LAND USE TYPE III APPLICATION

1010 SE ASH STREET

LU 20-12348 HR

April 24, 2020

DETAILS | Driveway Location

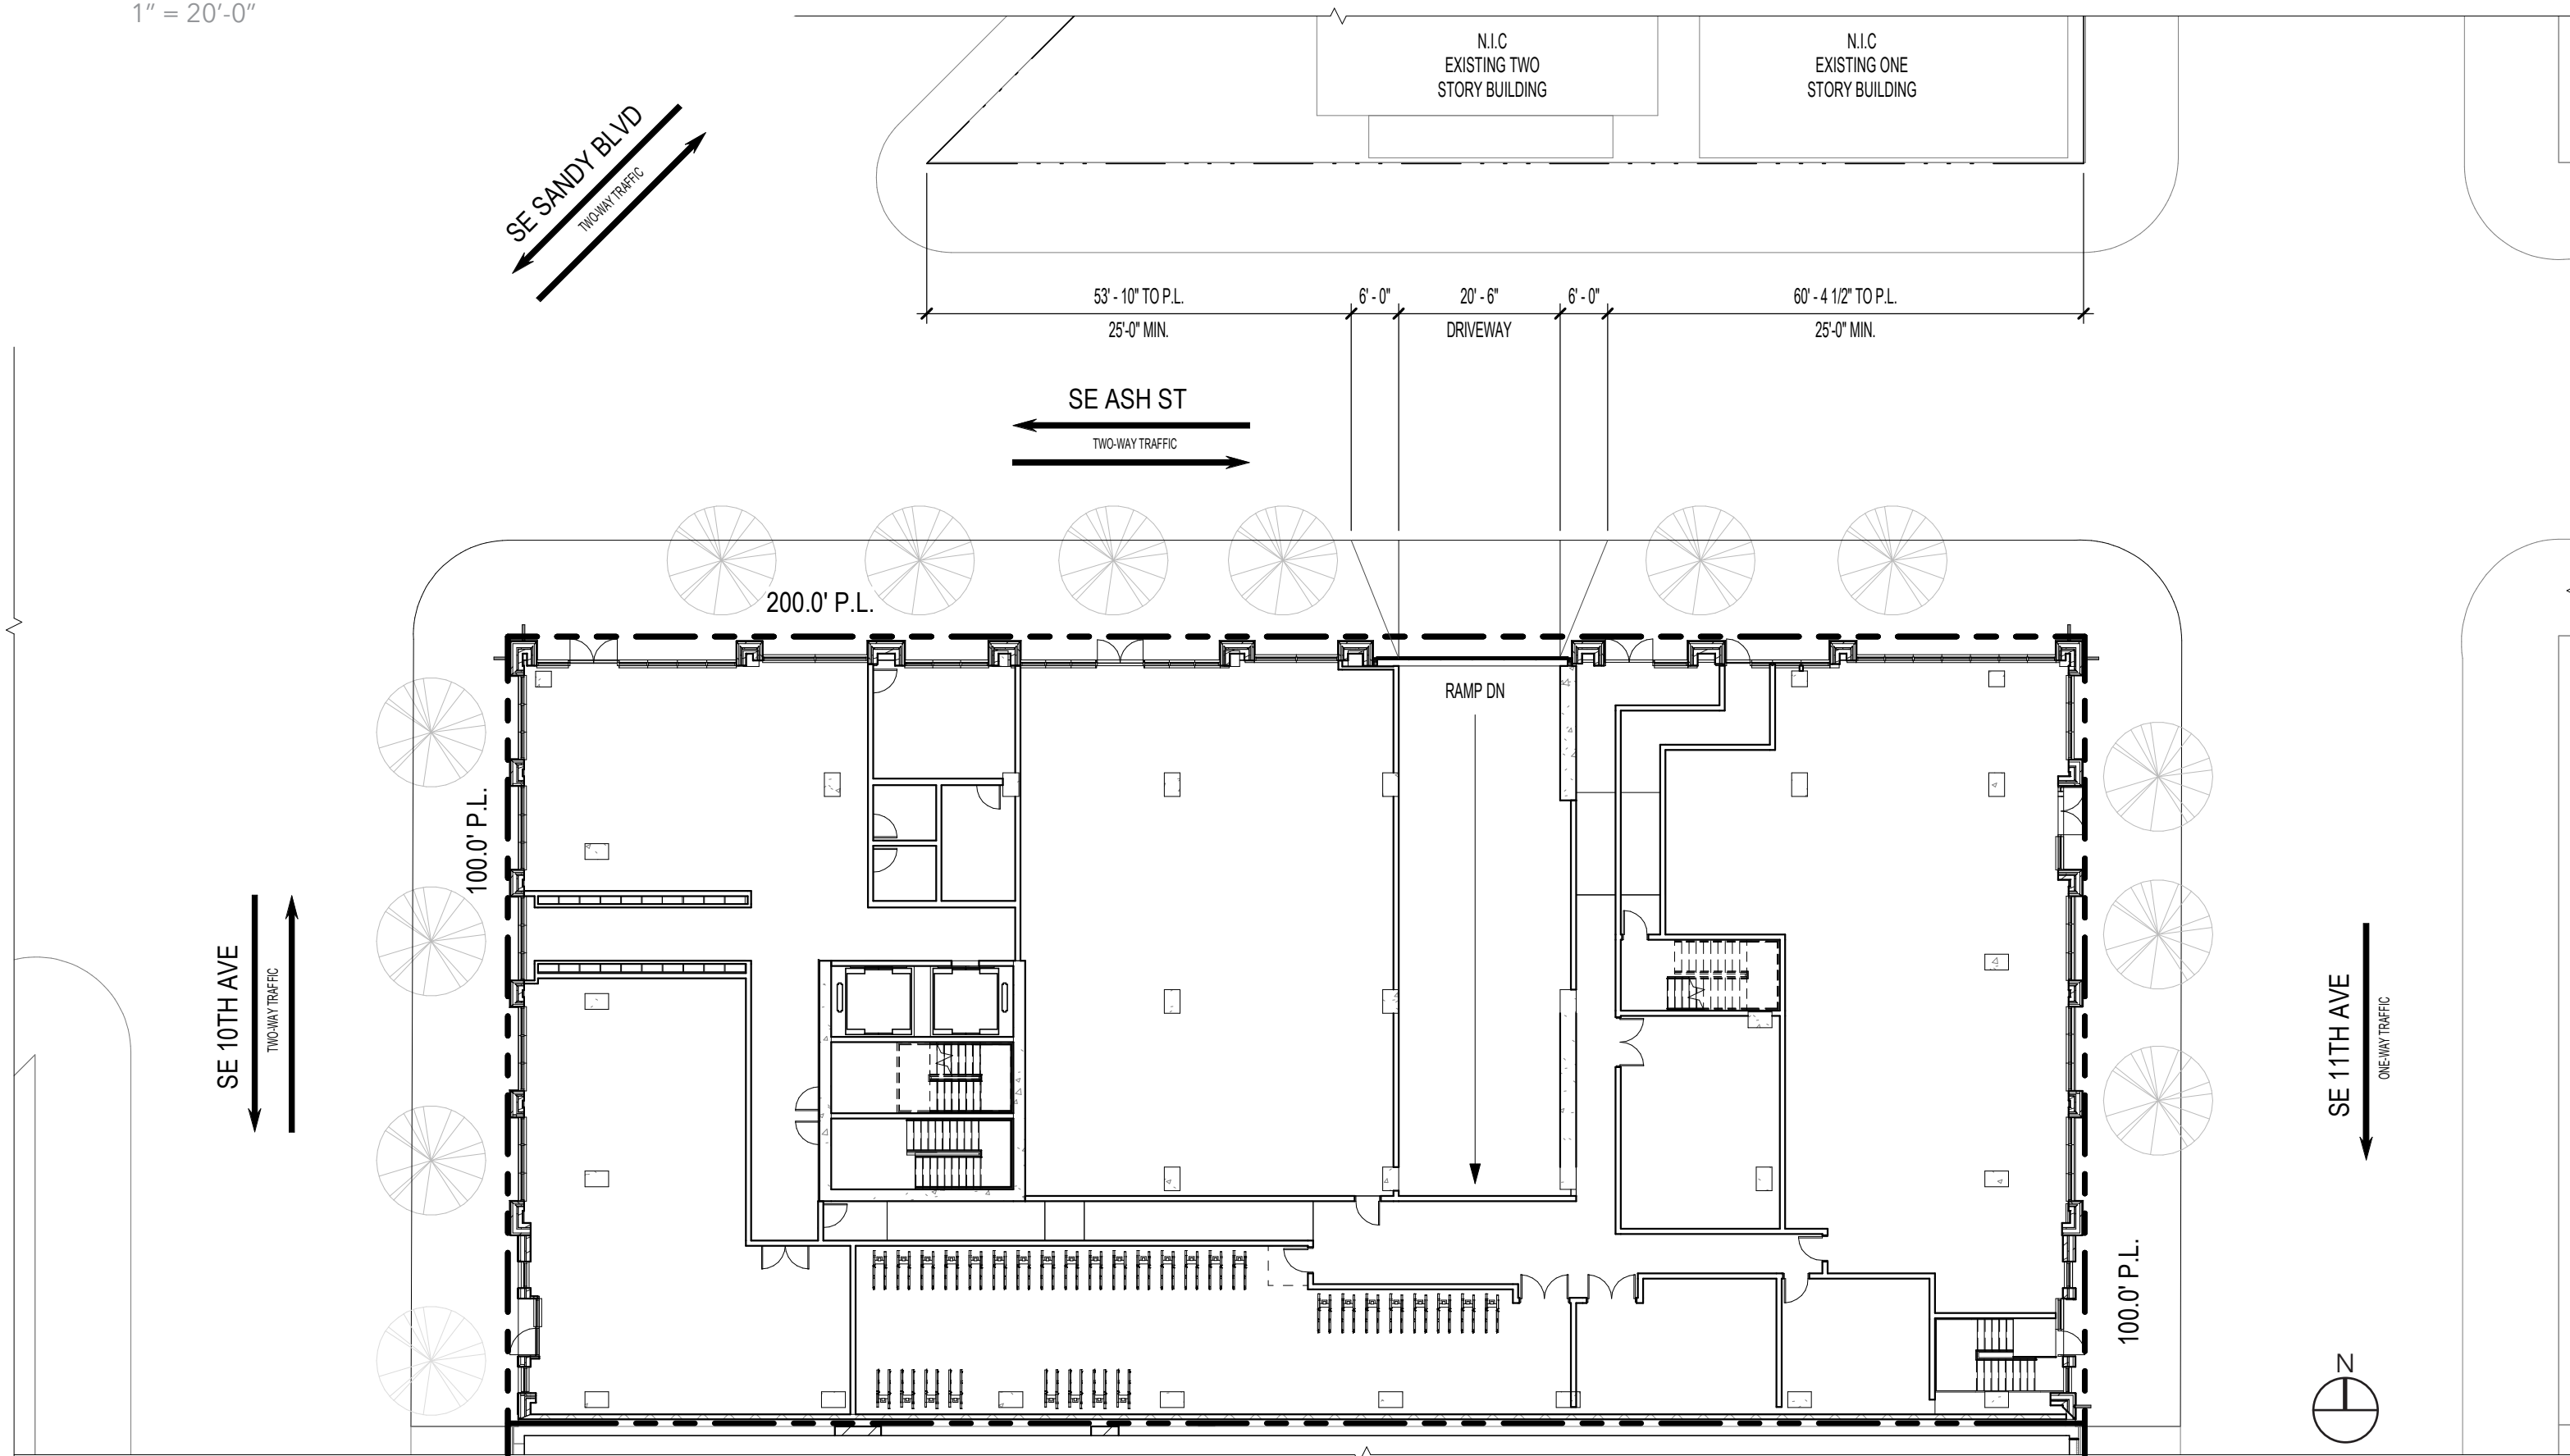
PBOT supports the alternate garage entrance location on SE Ash St. conceptually shown on sheet C77

More detail is needed to determine the driveway width and exact location, but PBOT is supportive of access from SE Ash St. Per 17.28.110.B, the driveway on SE Ash St. must be at least 25 feet from the corner of a lot where two streets intersect. This means the driveway should be at least 25-feet from the property’s corner at SE Ash St. and SE 11th Ave. as well as being at least 25-ft east of the property corner across SE Ash St. at the intersection of Sandy Blvd. and SE Ash St. It is not entirely clear on sheet C77 where the driveway is proposed. The alternative elevation on sheet C79 shows the garage door being in a location which appears to exceed 25-feet from either intersection. An updated site plan with dimensions will be needed prior to PBOT support for the land use decision.

Response: See driveway location exhibit C.42.

DETAILS | Garage Speed Ramp

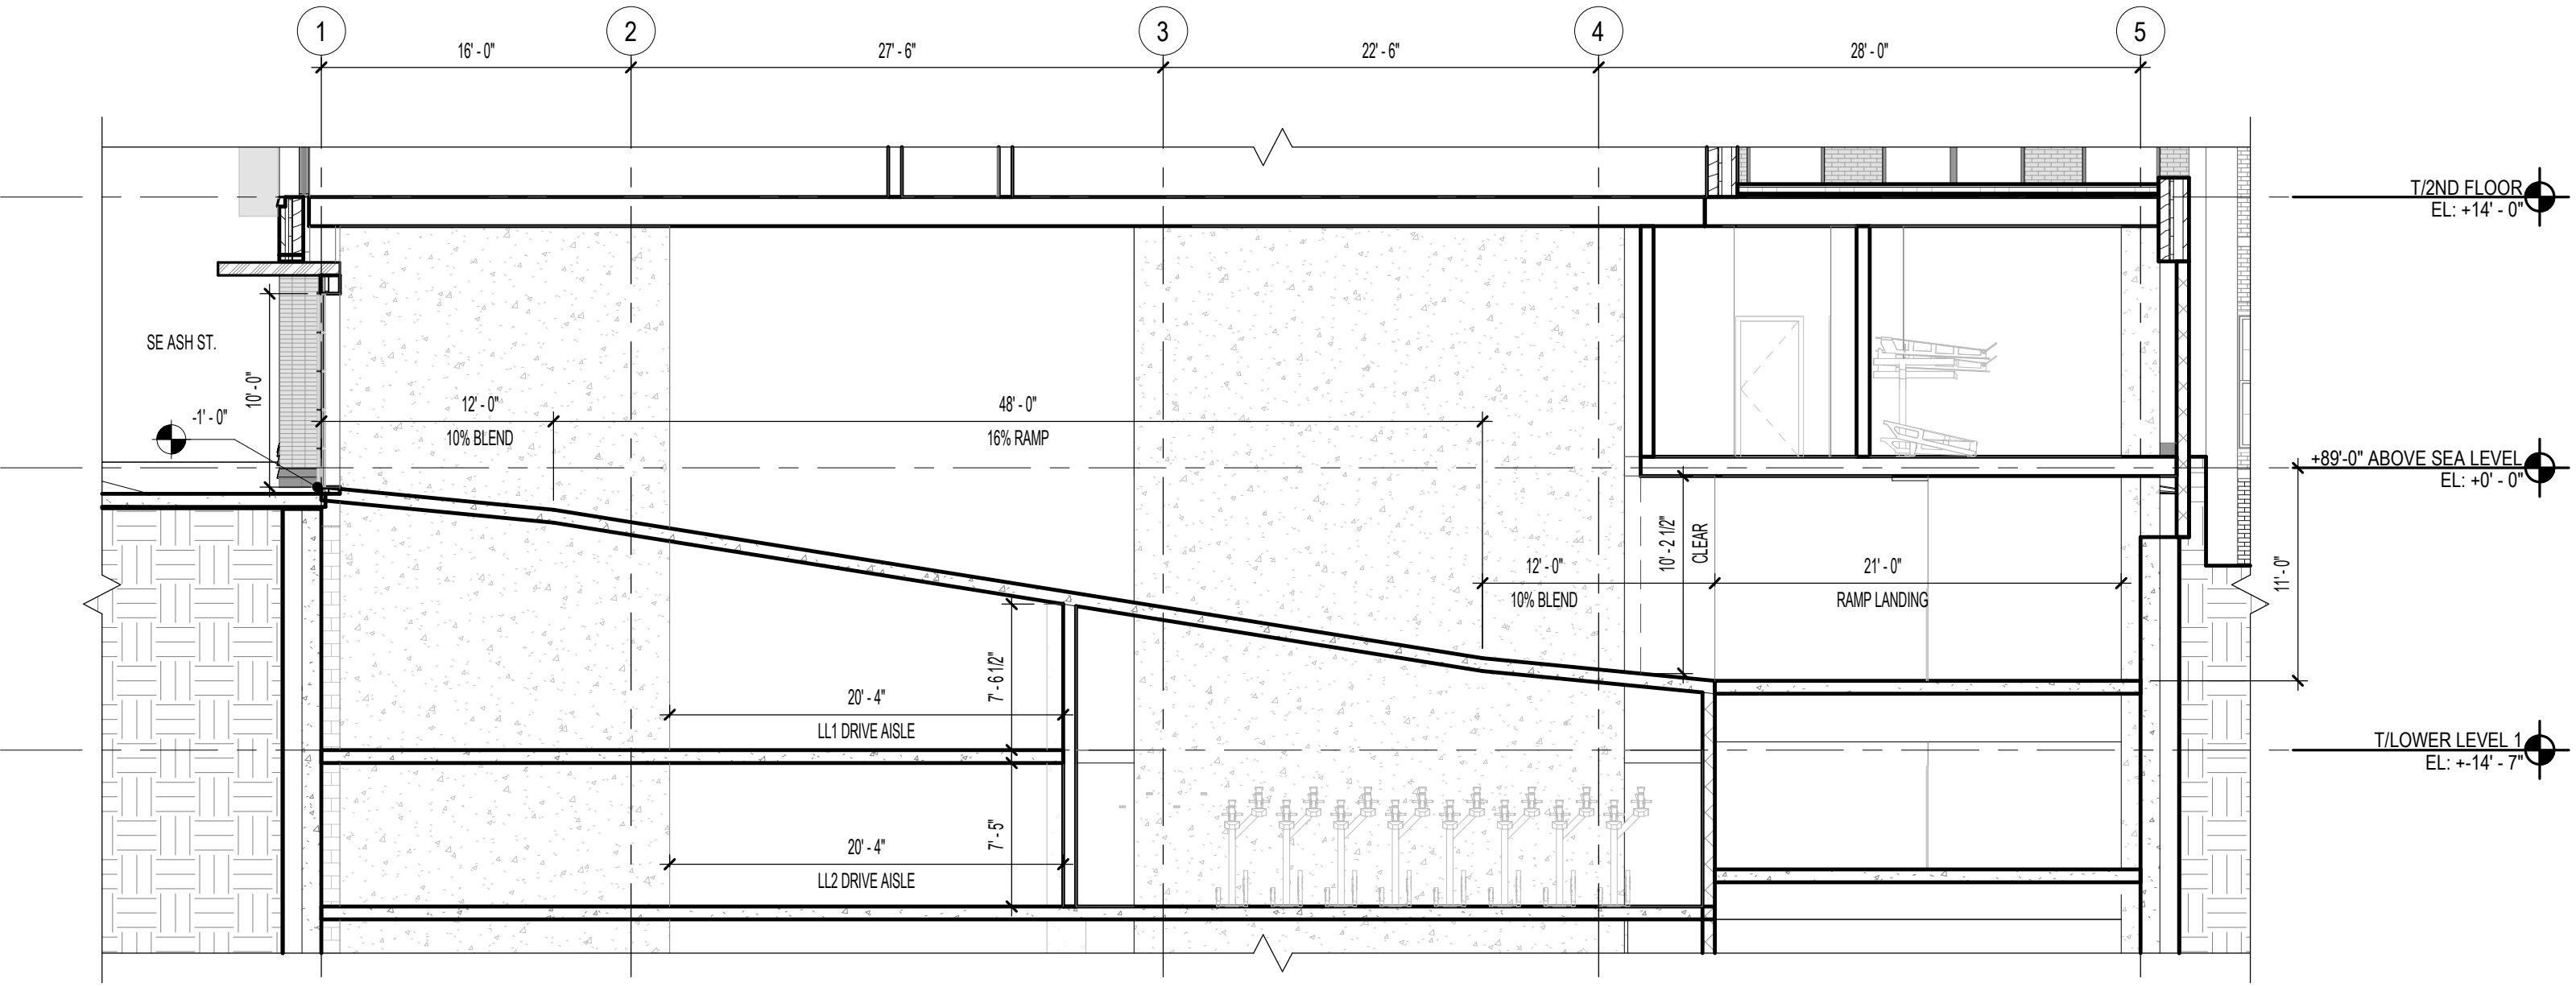
Any access control mechanism (ie garage door or gate) within 20-feet of a property line requires a Driveway Design Exception. The Driveway Design Exception must be approved by a PBOT Development Review Traffic Engineer prior to PBOT support of the land use request. None has been submitted to date, likely due to the need to provide time to fully design the relocated driveway. Based on the preliminary section on sheet C78 showing the relocated driveway, the grade of the ramp

will exceed 16%. As such, a Driveway Design Exception must be approved by a PBOT Development Review Traffic Engineer prior to PBOT support of the land use request. This should be done via the same Driveway Design Exception application as review of the access control mechanism. Additional information on these two topics is at the end of this document.

Response: Modifications to the ground floor plan allow the first floor slab to be raised high enough to provide a 16% ramp so that a slope exception is not required. See C.26-C.28 for basement and first floor plans and C.43 for ramp section. The garage is intended for residents only and the overhead door will be the only access control mechanism for parking access. A Driveway Design Exception has been submitted to allow the garage door/access control mechanism within 20’-0” of the property line.

DETAILS | Garage Door

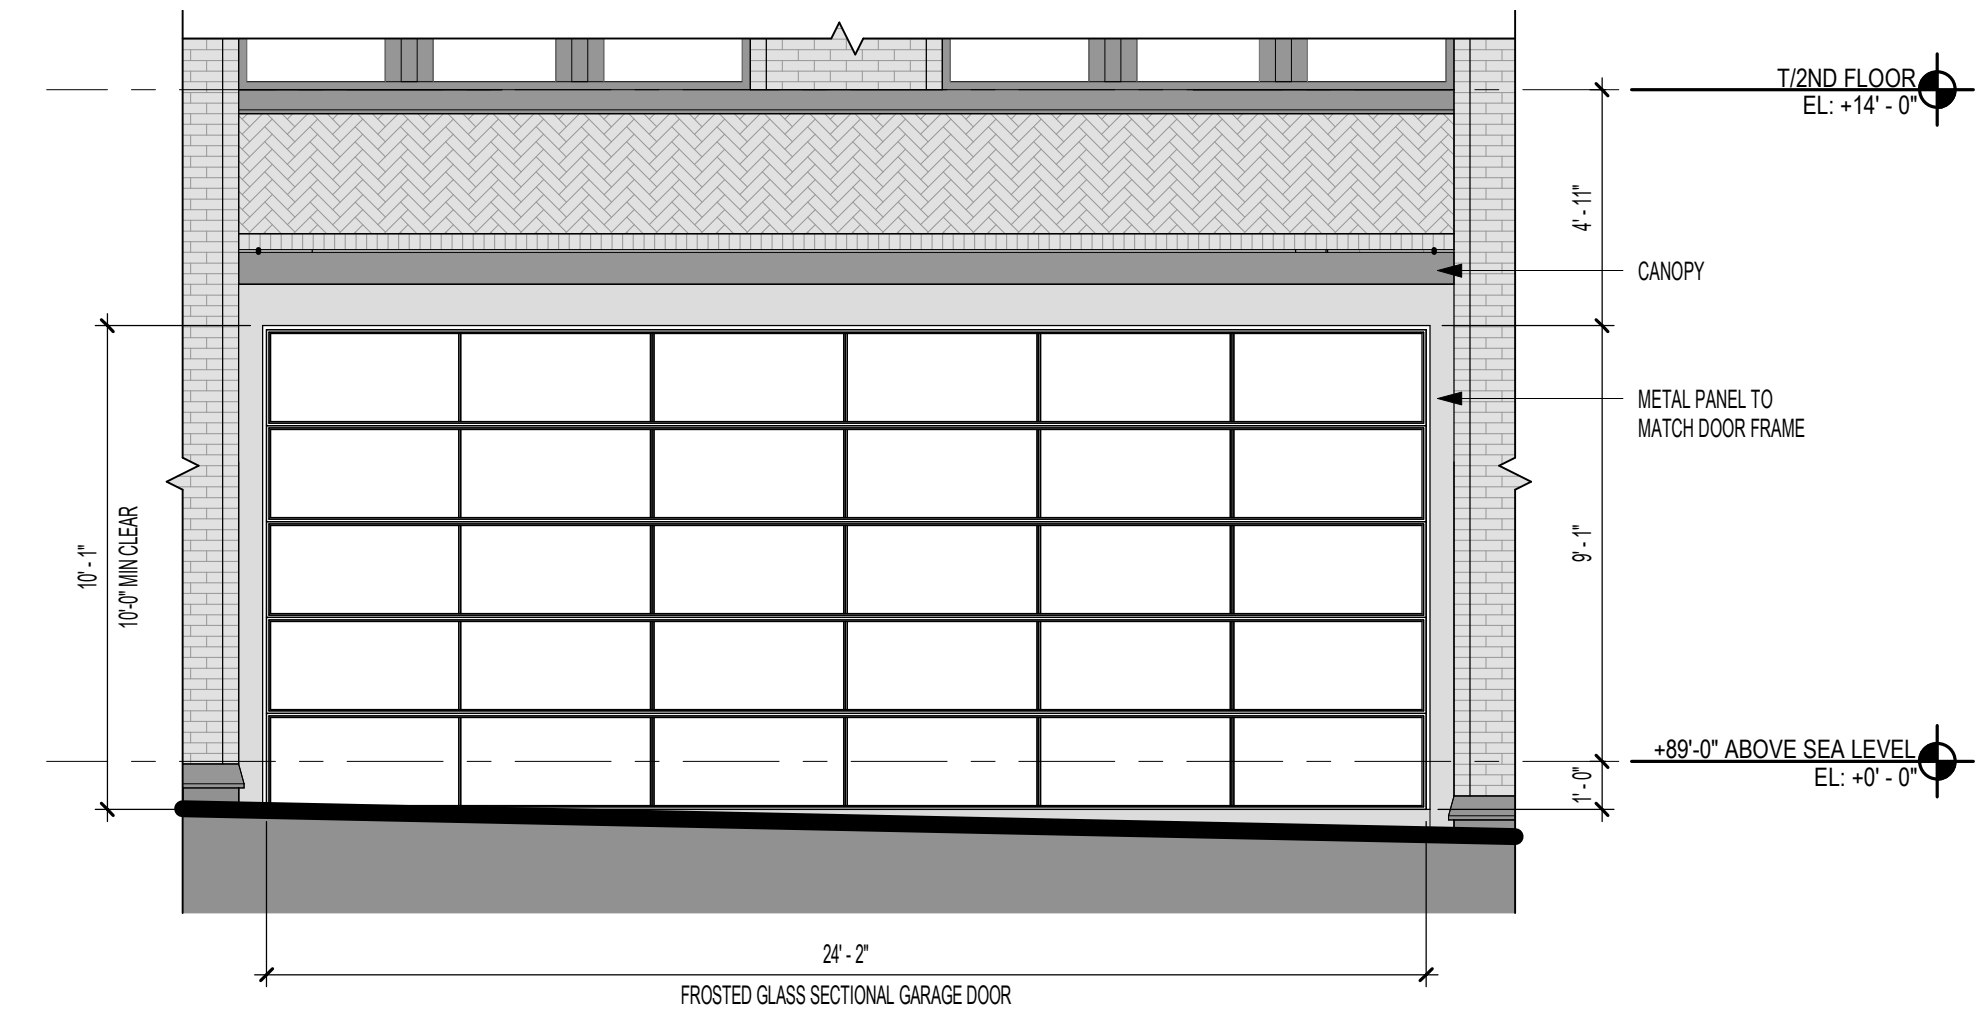
The new garage opening spans two bays, however the garage door does not fill the entire opening and the adjacent wall next to the garage door has the same aesthetic as the garage door. Please provide additional enlarged details of this area so that staff can understand the difference between the garage door and the adjacent wall.

Response: Garage door is proposed to span full double bay. See garage door exhibit C.44 for plans details.

DETAILS | Typical Detail & Residential Window Product Info

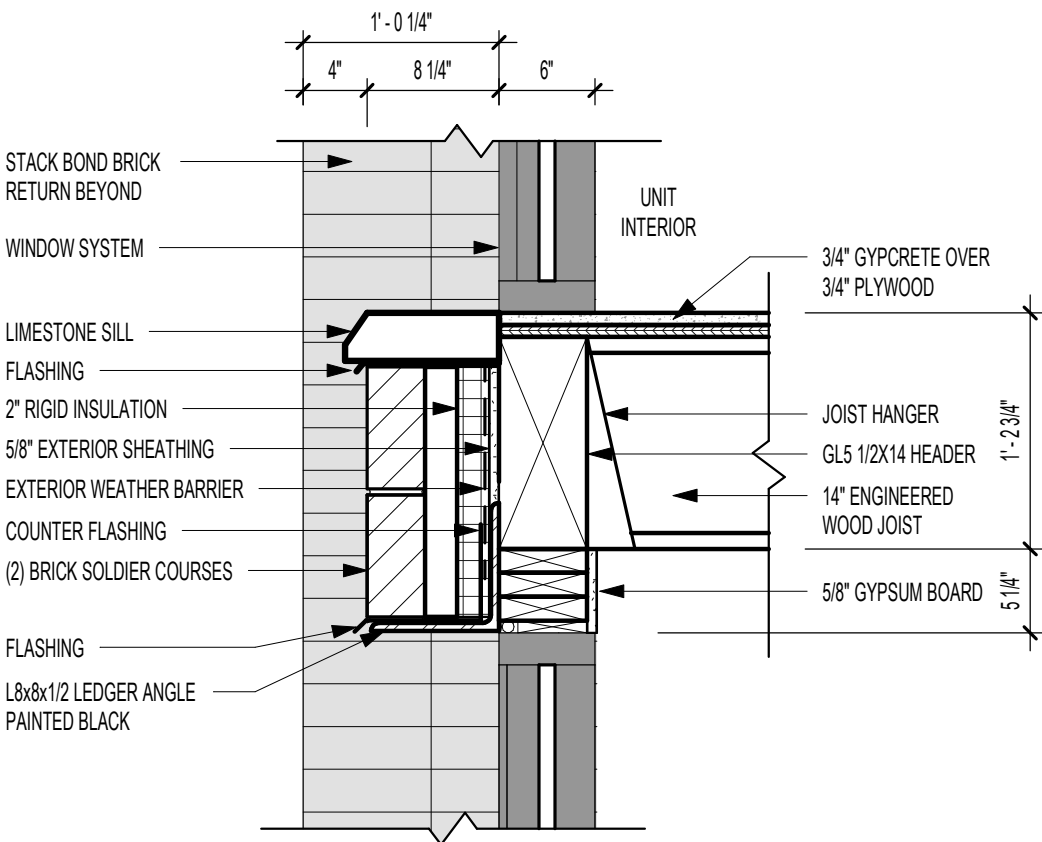
Window openings should be trimmed with a brickmold or casing around the window sashes so that the sashes are not immediately adjacent to the brick exterior wall. This would be similar to the design of the historic Troy Laundry building windows, thus making the proposed building more compatible. It also appears that many of the upper level windows are designed to look like hung sashes

with a center rail or muntin, but do not actually function as a hung window because the panes of glazing are in the same line. Staff is not supportive of false hung sashes and suggests these be revised to true hung windows in order to meet compatibility criteria. This may result in reduced window height and taller spandrels.

Response: Casing details have been provided, see exhibit C.48 for window product. Windows are aluminum frame - the top window is fixed and the lower window is an awning window. This detail allows all the glass on the facade to be aligned. The goal is not to mimic the detailing of the Troy Laundry Building but instead provide a modern building that complements the architecture.
